## **Barrio Developments**

Demolition of existing building, and construction of a seven level residential flat building, comprising 20 apartments and 38 tourist accommodation rooms and ancillary car parking and landscaping.

### **2 Canning Street, Glenelg North**

DA 110/M004/19

Figure 4: 6.4m long refuse vehicle collection

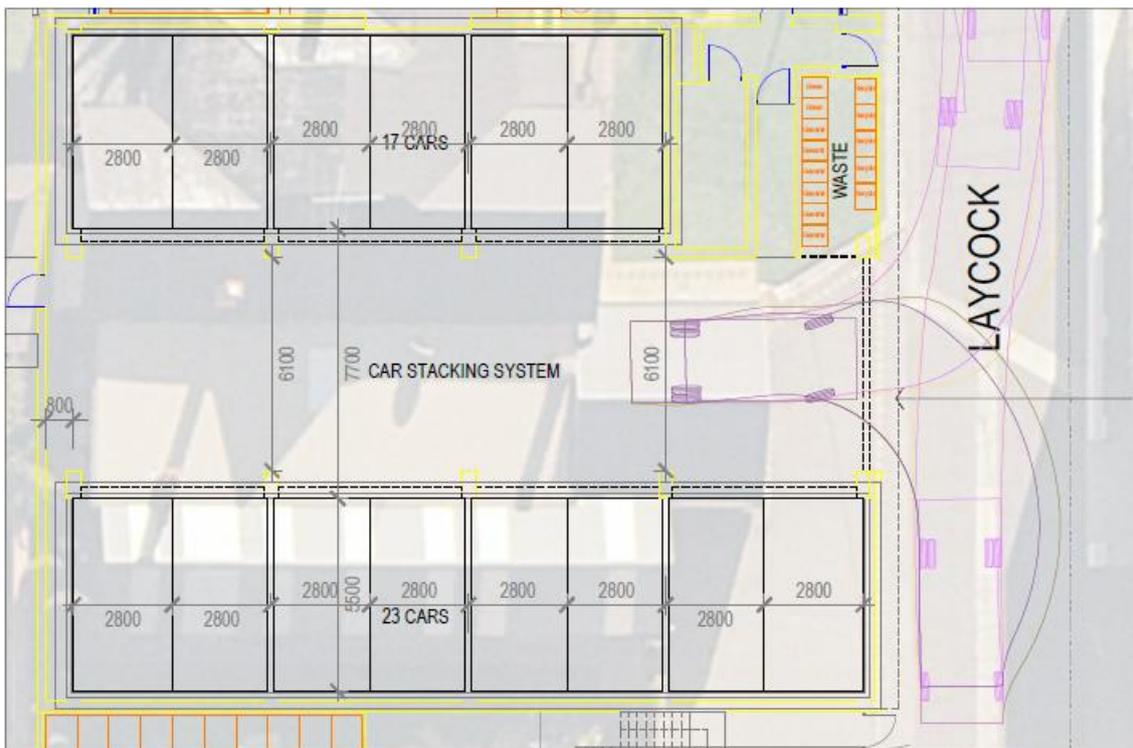
Figure 4 confirms a vehicle must cross onto the opposite side of the lane to be able to exit increasing the chance of accidents.

Figure 5: 8.8m long refuse vehicle collection (if required with vehicle passing)

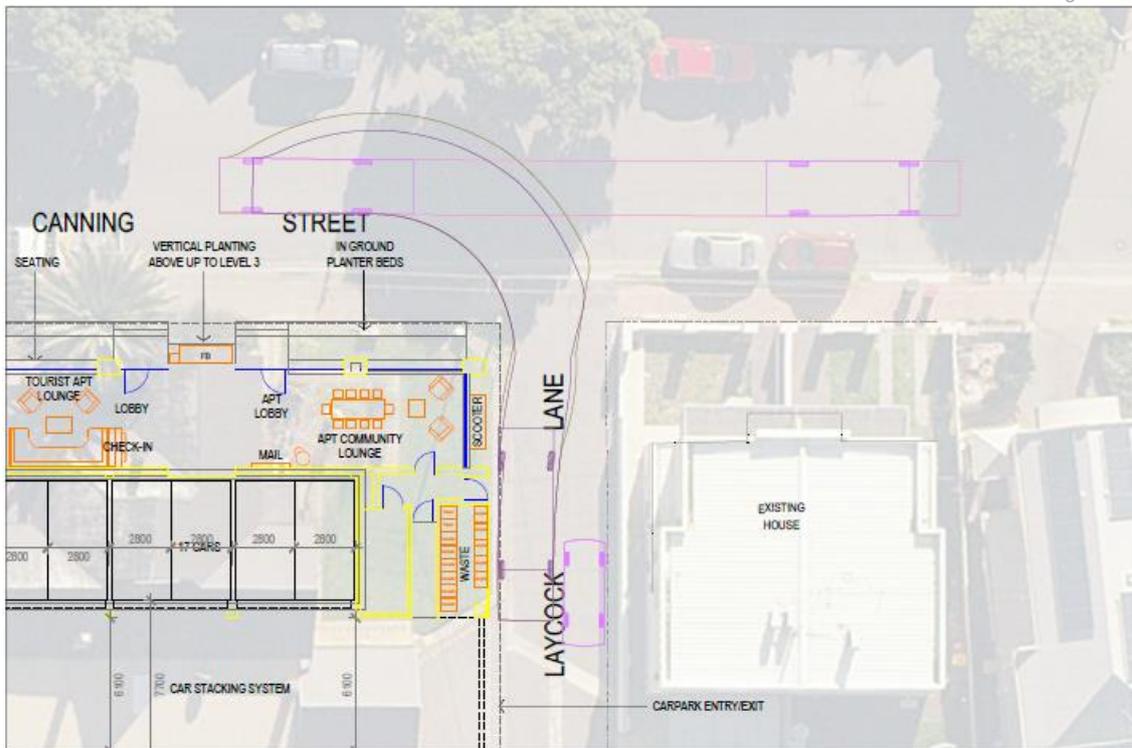
Figure 5 shows only a *small rigid vehicle* can only enter and exit the carpark, crossing the entire width of the lane, this vehicle will block access to the users of the carpark while the waste collection is being undertaken causing dangerous circumstances and vehicle banking for Laycock Lane and Canning Street.

**Figure 3: Pedestrian access within the car park**

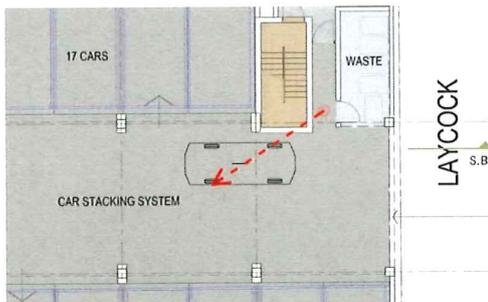
- the pedestrian access within the car park is adjacent the egress lane, with no sightlines for pedestrians prior to stepping into the travel path of the vehicle, as illustrated in Figure 3.

The above situation will result in an unsafe situation for pedestrians when entering the car park to access their vehicle. I am of the view that this will result in an unacceptable risk for pedestrians;

**Figure 4: A typical waste/recycling vehicle unable to access the site**

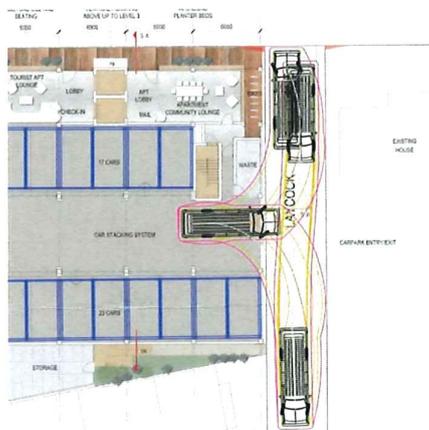
restrictions for waste collection. Further, there are no waste collection companies which collect recycling using a small refuse vehicle. A typical recycling vehicle would not be able to access the site, as illustrated in Figure 4;

The above figure illustrates that the recycling vehicle would not be able to access the site, even if a small refuse vehicle could be used for waste. Accordingly, the proposal has not demonstrated that it can cater for the recycling vehicle requirements or green waste collection;

**Figure 5: Proposed development will obstruct sightlines**

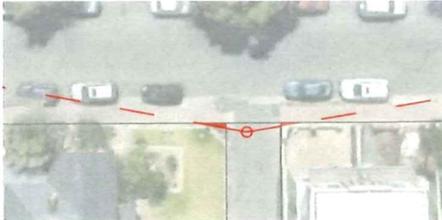
- the sightlines at the intersection of Laycock Lane and Canning Street will be compromised by the proposal, as illustrated in Figure 5.

While the proposal is confined to within the subject site, it is proposed to extend to the existing boundary. The volumes exiting at this location will be substantially increased when compared to the existing very low volumes, thus increasing the potential risk at the intersection. Further, while the drivers view does extend across the corner of the site, in reality sightlines are currently met due to the set-back of the existing dwelling; and

**Figure 6: Turn constraints at the intersection**

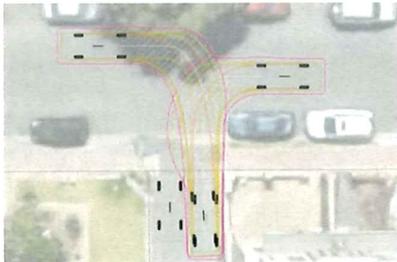
- there are existing turning constraints at the Laycock Lane/Canning Street intersection created by the narrow lane width, solid fence and stobie pole. Figure 6 illustrates this constraint.

The above issue will be exacerbated by an increase in turning movements at the intersection.
